Response to SDAA Audit Question

Question Number: A-6.2-3

Audit Question A-6.2-3

Figure 6.2-7: Maximum Containment Internal Pressure - Peak Containment Vessel Pressure Case

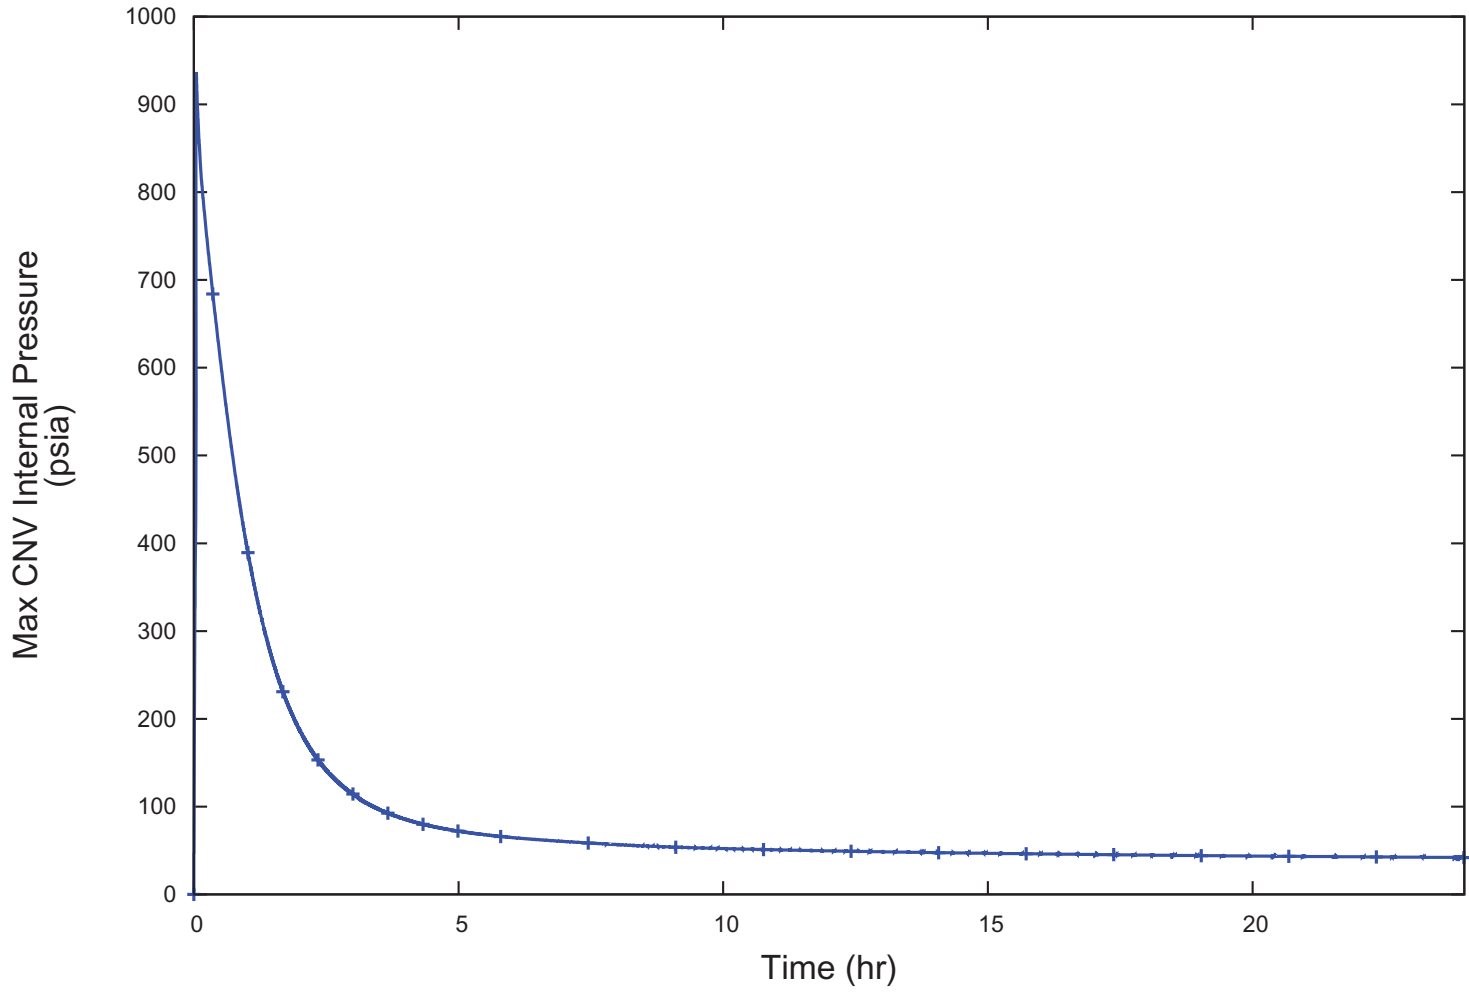
SDAA Section 6.2.1.3.5 (Description of the Long-Term Cooling Model) states that the containment response analyses demonstrate that the CNV pressure and temperature rapidly reduce and remain at acceptably low levels following postulated mass and energy releases, including LOCA, into the containment. NuScale DSRS Section 6.2.1.1.A, Acceptance Criteria 2 states that to satisfy GDC 38 to rapidly reduce the containment pressure, the pressure should be reduced to less than 50 percent of the peak calculated pressure within 24 hours after the postulated design basis accident. SDAA Figure 6.2-7 shows that for the limiting CNV pressure DBA, the CNV internal pressure reaches its peak of 937 psia at 170 sec, and then decreases to about 690 psia (74% of the peak) around 1400 sec. The figure does not show the CNV pressure reducing to less than 50% of peak pressure (~468 psia) within 24 hours, as mandated by the Acceptance Criteria 4. Figure 6.2-7 needs to be updated to demonstrate that the GDC 38 requirement is met.

Figure 6.2-7 below shows the limiting containment pressure case extended for 24 hours, with the reactor pool temperature boundary condition maintained at 140°F. The containment pressure is less than 50% of the peak pressure within a few hours after the break occurs and remains acceptably low. This figure has been updated in the SDAA.
